D350-748-103
Job Sheet 188321

Part Name: AS350 / AS355 Stainless Steel Fwd Crosstube

DRAWING NO. D350-748-143
TITLE CROSSTUBE (AS 350/355 HI FWD)

DRAWING NO. D350-748-143	TITLE CROSSTUBE	REV. A	DART AEROSPACE LTD ENGINEERING ORDER		D.E.O. NO. D350-748-143-A-1	SHEET NO. SHEET 1 OF 1	SCALE NTS
DRAWN <i>qp</i>	CHECKED <i>ASS</i>	MFG. APPR. <i>GLM</i>	APPROVED <i>GLM</i>	DE APPR. <i>GLM</i>			
DATE 15.11.18	DATE 15.11.18	DATE 16-02-19	DATE FEB 19 2016	DATE 2016-02-19

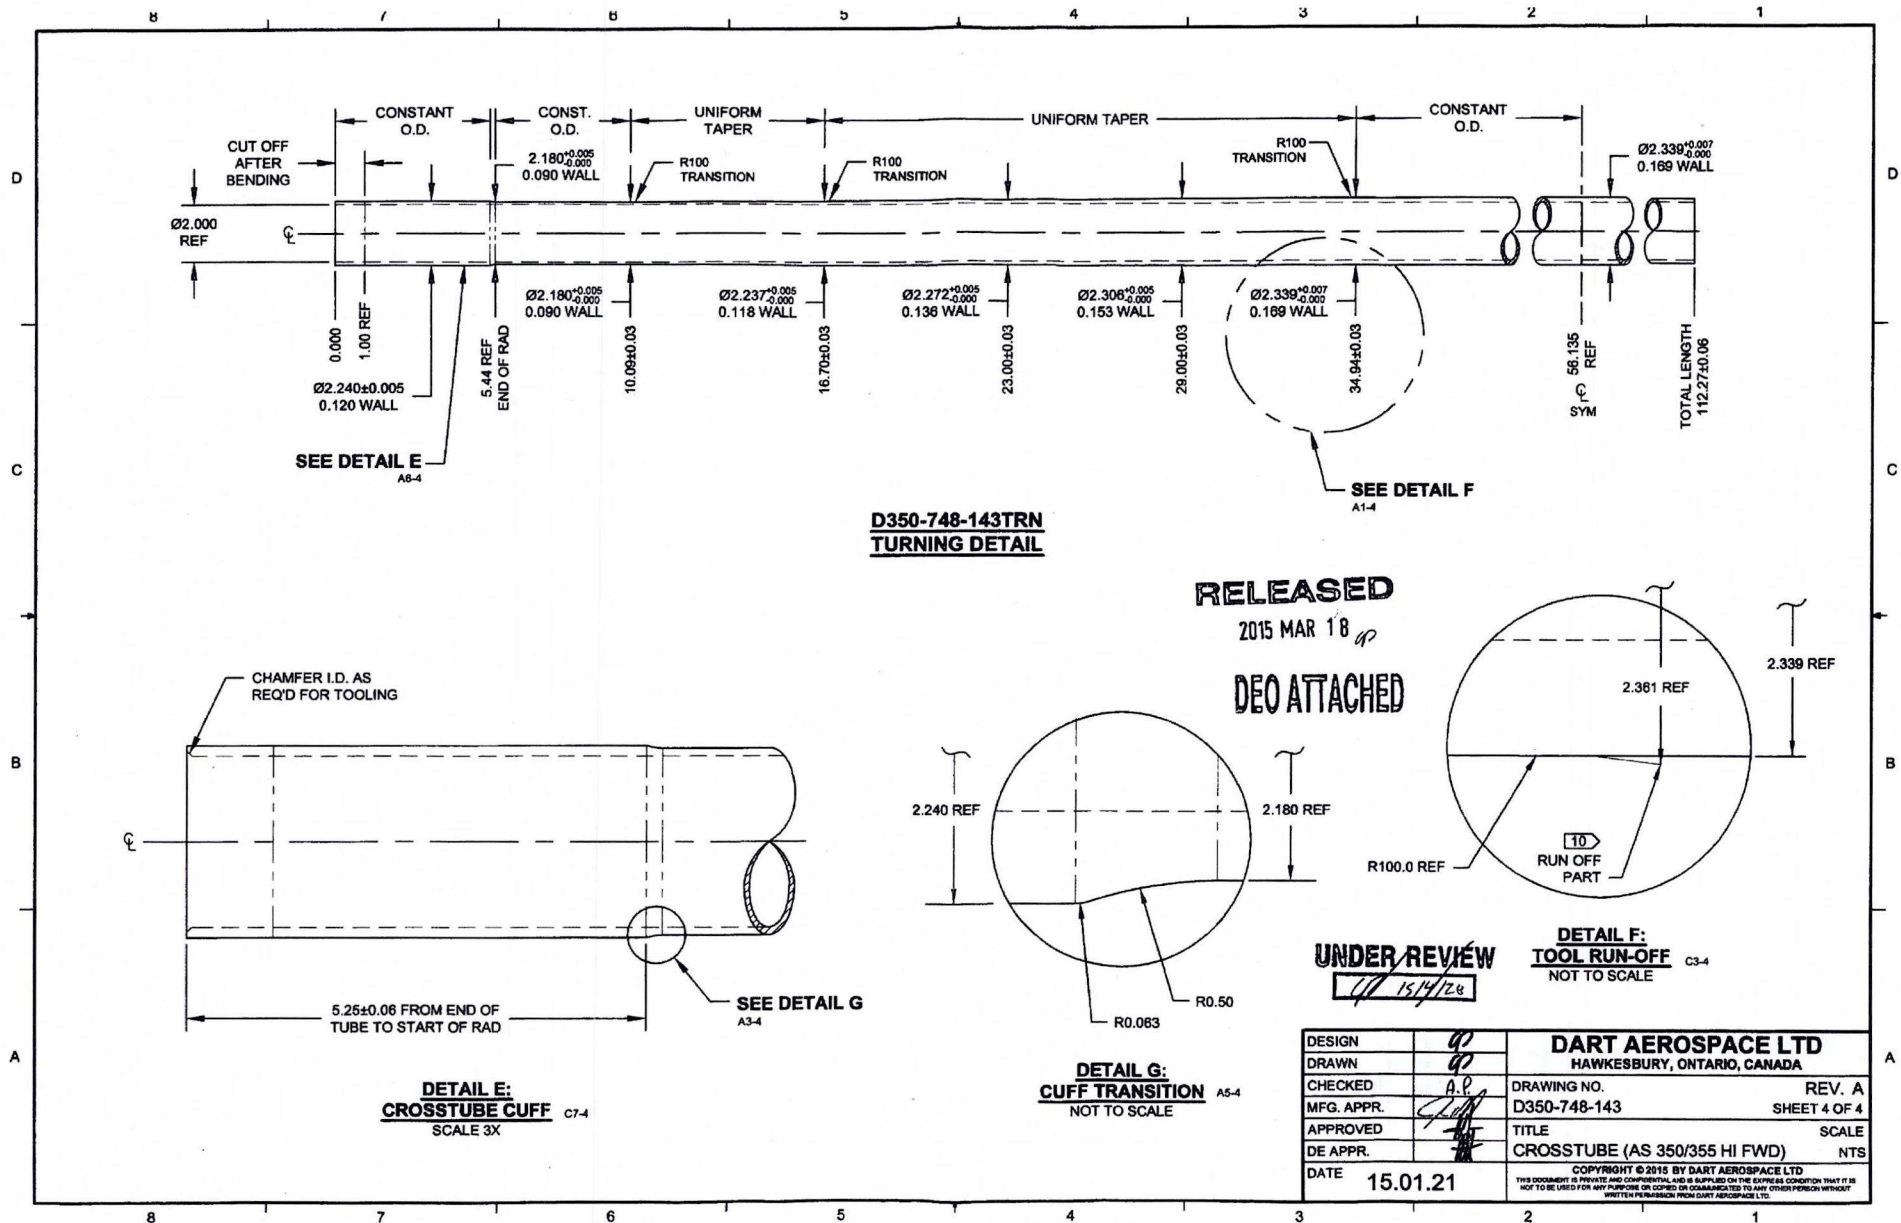
AMEND NOTE 2 (SHEET 1) AS FOLLOWS:

- 2) FINISH: PREPARE SURFACE PER DART QSI 005 4.1.4
 PRIME INSIDE AND OUTSIDE PER DART QSI 005 4.2
 PAINT OUTSIDE PER DART QSI 005 4.2
 OR
 POWDER COAT WHITE (4.3.5.2) PER DART QSI 005 4.3
